# APPENDIX L

## **North Dumfries SWMMP PIC Comments**

Provided by member of the public John Palmer,  
22 Nith River Way  
(519) 590 3065  
[John@2palmers.org](mailto:John@2palmers.org)

March 24, 2021

**Figure 4.10.4 Schematic of a perforated pipe system receiving roof runoff only**

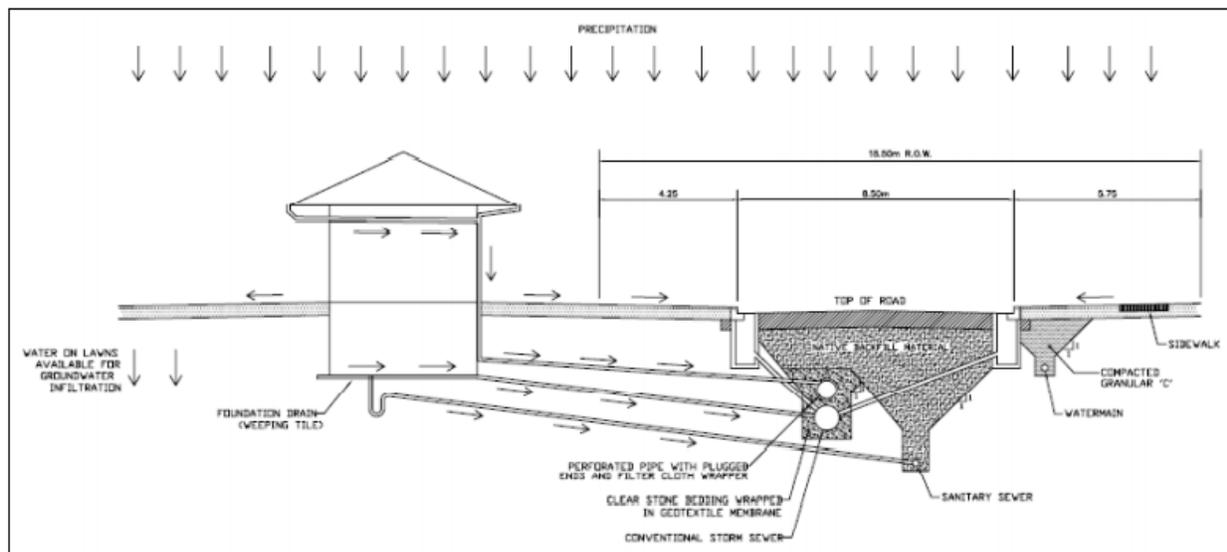
Consider perforated pipe storm sewers and third pipes for roof runoff. Both CVC and TRCA have excellent data on runoff reduction and water quality benefits, some of it from studies carried out by J.F. Sabourin and Associates.
